Access Compliance Report

Public Rights-of-Way

(Curb Ramps)

Intersection ID: N/A	Main Street: S COLLEGE ST	Cross Street: E 3RD ST	Location: W
ADA ID: CF9AA22F46C3	Ramp Type: PerpDiag	Initial Pass/Fail: Pass	Overall Compliance: No
Severity Score: 0.25			
Codes/Mitigation Info/Possible Solution		Field Measurements/Component Compliance

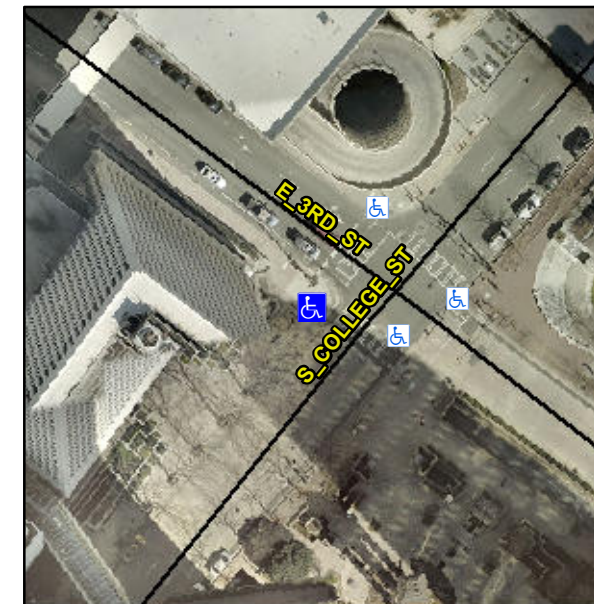
Not Found, R304.5.3, R304.2.1

Compliance	Description	Data	Compliance	Description	Data
N/A	Ramp Length (in)	85.0	Yes	Ramp Slope (%)	8.1
Yes	Ramp Width (in)	60.0	No	Ramp XSlope (%)	3.3
N/A	Flare Type LT	Sloped	N/A	Flare Type RT	N/A
N/A	Flare Slope LT (%)	2.7	Yes	Flare Slope RT (%)	7.1
N/A	Flare Traversable LT?	Yes	N/A	Flare Traversable RT?	Yes
No	Landing Length (in)	40.0	Yes	DWS Provided?	Yes
Yes	Landing Width (in)	60.0	Yes	DWS Contrast?	Yes
Yes	Landing Slope (%)	0.2	Yes	DWS Length (in)	24.0
Yes	Landing X Slope (%)	2.4	Yes	DWS Full Width?	Yes
N/A	Landing Curb? (Y/N)	No	Yes	DWS Offset (in)	0.0
N/A	Shared Landing?	No			
Yes	Gutter Ponding?	No	Yes	Gutter Slope (%)	1.6
Yes	Gutter Lip Ht (in)	0.0	Yes	Gutter X Slope (%)	1.4
N/A	Painted X Walk1?	Yes	N/A	Painted X Walk2?	Yes
	X Walk 1 Direction	To SE		X Walk 2 Direction	To NE
N/A	X Walk 1 Width (in)	111.0	N/A	X Walk 2 Width (in)	108.0
	X Walk 1 Slope (%)	2.5		X Walk 2 Slope (%)	4.0
	X Walk 1 X Slope (%)	2.1		X Walk 2 X Slope (%)	0.8

Yes	Ramp inside XWalk1?	Yes	Yes	Ramp inside XWalk2?	Yes
	Road Slope (%)	2.8	N/A	Clear Space?	Yes
	Road X Slope (%)	3.8	No	Clear Space to XWalk (in)	45.0
Yes	Any Obstructions?	No	Yes	Storm Grate/Utility Hazard?	No
	Obstruction Type			Storm Grate/Utility Type	
		N/A			N/A
			Yes	Surface Condition? (G/P)	Good

Remove & Replace Curb Ramp With Two New Directional Ramps or Equivalent. Restripe Crosswalk(s) To Provide Clear space.
